**RE: Official Plan Amendment No. 25 and Z-18-18
Response to City staff and Agency Comments
164-168 King St S and 8 George St, Waterloo
OUR FILE 1716B**

The purpose of this Response Letter is to provide additional supporting details and responses to comments received from City staff and circulated agencies in a letter dated February 25, 2019. The Response Letter has been separated into subsections to respond to specific issues or concerns raised by staff or circulated agencies and the topic areas contained in the aforementioned letter.

Figure 1
**Heritage /
 Development
 Context Plan**

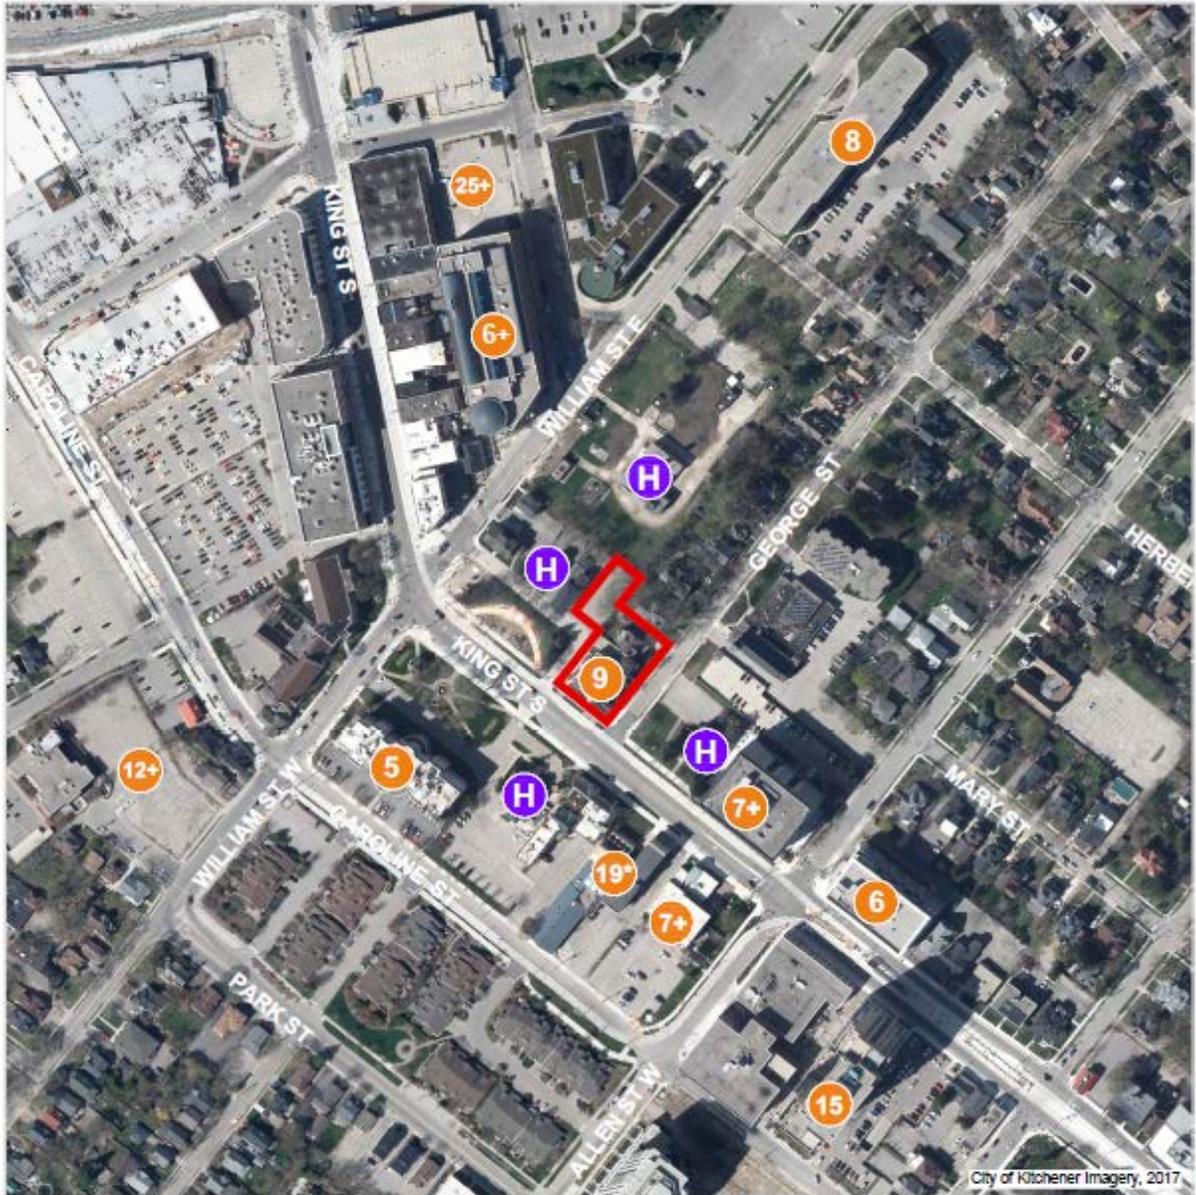
The Municipal Heritage Committee has reviewed and supported the Heritage Impact Assessment (HIA). The comments in this section appear to be focused on the design of the building (specifically its building materials) and proposes the notion that step backs on all four facades represents a sympathetic design in relation to the Regional Pumping Station and heritage properties in the general vicinity, none of which abut the subject lands (other than the Pumping Station). While we disagree that mimicking

The same section of the letter refers to shadow impacts and several references to a reduction in building height as satisfying many of the design components. We previously provided a Shadow Study that complies with the standards in the Urban Design Manual. Furthermore, we believe a 31.5 metre tall building is appropriate in this context, adjacent to King St and within a short walk of both ION and the Uptown Core. The Official Plan supports this height, by designating the majority of the lands for 40 metres (the entire building is located on the portion of the lands designated Medium High Density). We do not agree that a reduction in height is warranted to satisfy any aspects related to designated heritage properties in the general area.

In this regard, we have included a Figure (Figure 1 on the following page) that shows the subject lands, the designated heritage buildings in the vicinity and the existing and approved mid and high-rise development. As the Figure demonstrates, there are multiple buildings in the immediate area with similar or much greater height, including buildings that abut properties with designated heritage buildings. Both existing, approved and planned mid and high-rise development exists along both William St and King St S, establishing a context of intensification, and in some cases, substantial height, that is compatible with the heritage resources.
